RENESAS TECHNICAL UPDATE

Product Category	MPU&MCU	Document No.	TN-H8*-A327A/E	Rev.	1.00
Title	About event counter PWM operation	Information Category	Technical Notification		
Applicable Product	H8/38086R Group H8/38076R Group	Lot No.	Reference Document	H8/38086R Group Hardware manual (REJ09B0182-0200 Rev.2.00) H8/38076R Group Hardware manual (REJ09B0093-0300 Rev.3.00)	
		All

The error correction of the hardware manual of event counter PWM operation of H8/38086R group and H8/38076R group, Please refer to the following for details.

Figure 13.4 Event Counter Operation Waveform

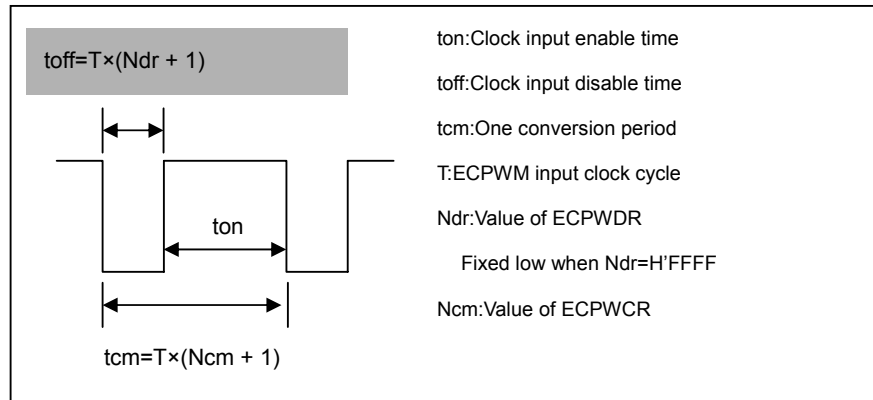
< Before change >

Figure 13.4 Event Counter Operation Waveform

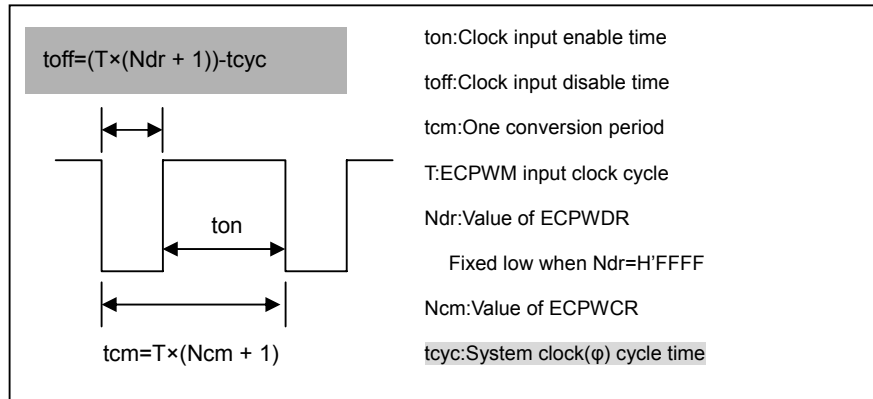
< After change >
